SUBJECT: ACCEPTANCE FOR REFERENCING WCAP-11736 REV. O.O, 'RESIDUAL HEAT
REMOVAL SYSTEM AUTOCLOSURE INTERLOCK (ACI) REMOVAL REPORT" IN PLANT
SPECIFIC SUBMITTALS

SAFETY EVALUATION BY THE OFFICE OF NUCLEAR REACTOR REGULATION
RELATING TO REMOVAL OF AUTO CLOSURE INTERLOCK FUNCTION

WESTINGHOUSE OWNERS GROUP
WCAP-11736, VOLUME I AND II

Project Title RHR ASI Deletion
V.C. Summer Submittal
WCAP-11835

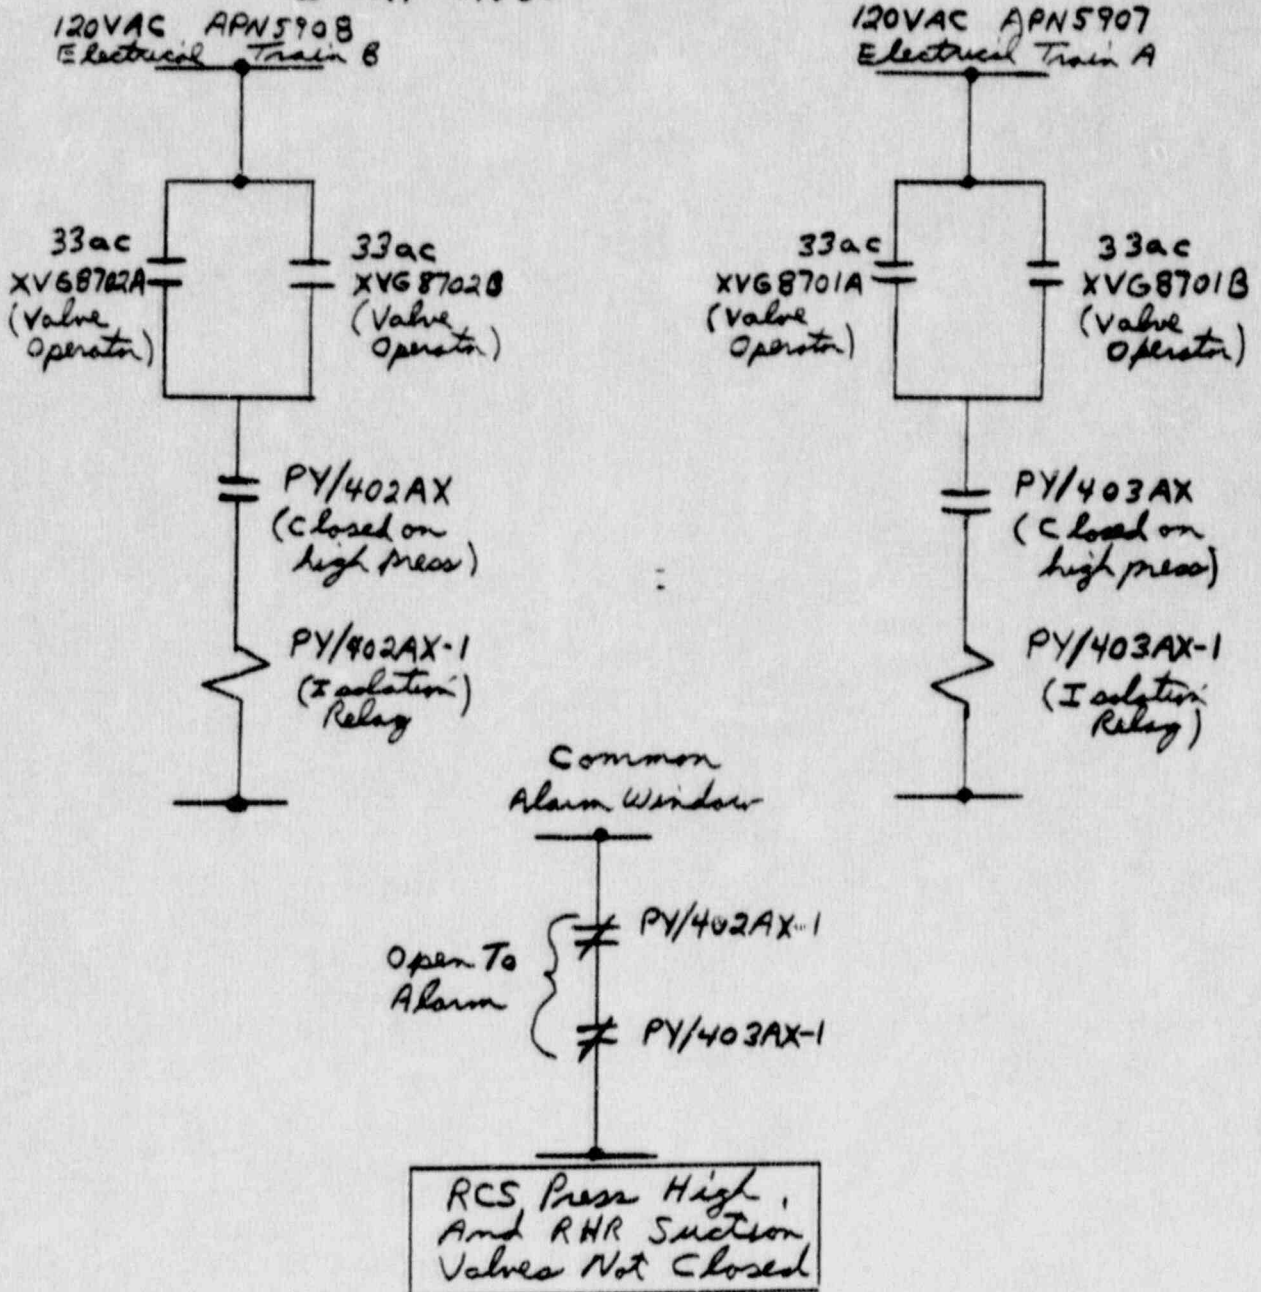
- Plant Improvements (1) *Does this mean a separate alarm window on the main control board for each valve or can this alarm be a common window for all four valves?*
- (1) An alarm will be added to each RHR suction valve which will actuate if the valve is open and the pressure is greater than the open permissive setpoint and less than the RHR system design pressure minus the RHR pump head pressure [justified by WCAP-11736].
 - (2) Valve position indication to the alarm must be provided from the stem-mounted limit switches (SMLSs) and power to the SMLSs must not be affected by power lockout of the valve [justified by WCAP-11736].
- (2) *V.C. Summer design uses limit switches on valve operator. Why the requirement to use stem mounted limit switches? Power removed from our valves will not affect alarm or limit switch operation.*

- # 1.) All four valves are alarmed on a common alarm window on the main control board. (see attached sketch).
- # 2.) Limit switches for V. C. Summer design are in valve operator not on stem. Removal of power will not affect alarm function. Alarm fed by separate power supplies.
